SUBJECT: WOLF CREEK GENERATING STATION - AMENDMENT NO. 63 TO FACILITY
OPERATING LICENSE NO. NPF-42 (TAC NOS. M77395 AND M77471)

AMENDMENT TO FACILITY OPERATING LICENSE

Amendment No. 63
License No. NPF-42

SAFETY EVALUATION BY THE OFFICE OF NUCLEAR REACTOR REGULATION
RELATED TO AMENDMENT NO.63 TO FACILITY OPERATING LICENSE NO. NPF-42
WOLF CREEK NUCLEAR OPERATING CORPORATION
DOCKET NO. 50-482
WOLF CREEK GENERATING STATION

FIGURE 3.4-4

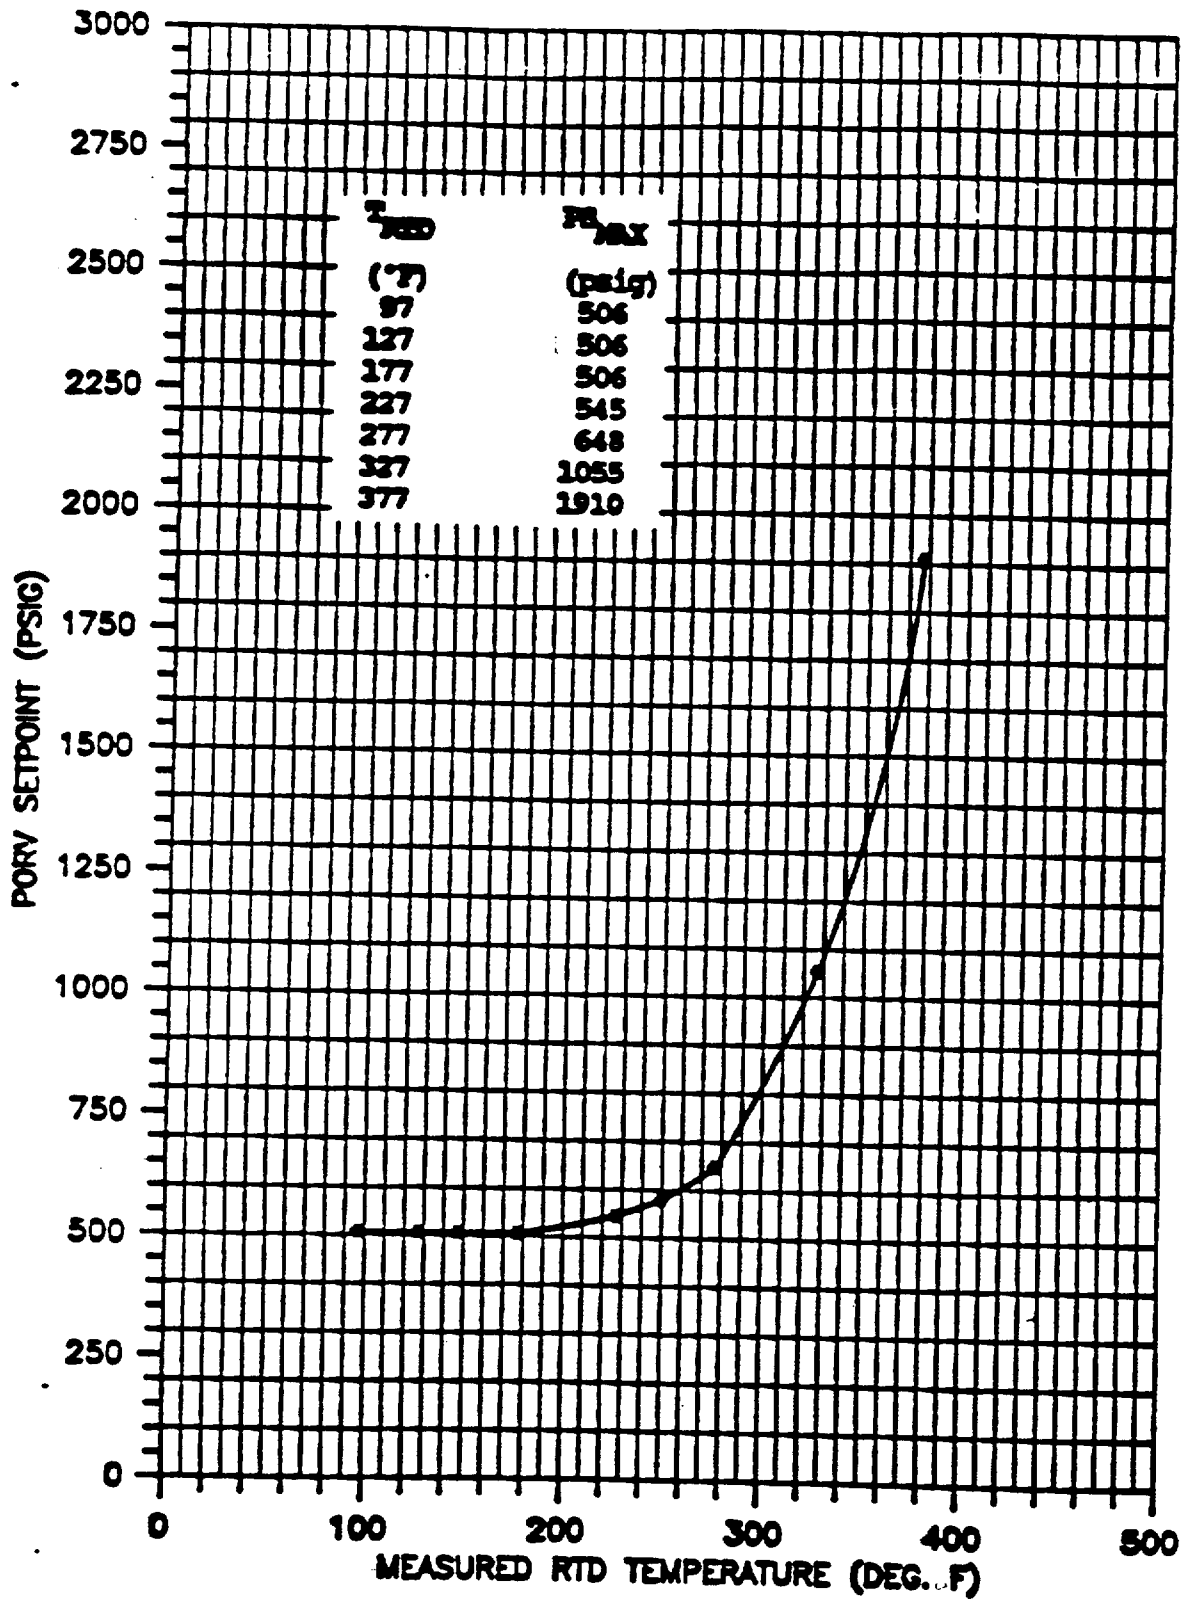
- a. Two residual heat removal (RHR) suction relief valves with Setpoints of 450 psig \pm 3%, or
- b. Two power-operated relief valves (PORV) with Setpoints which do not exceed the limit established in Figure 3.4-4, or
- c. One RHR suction relief valve and one PORV with Setpoints as prescribed above.
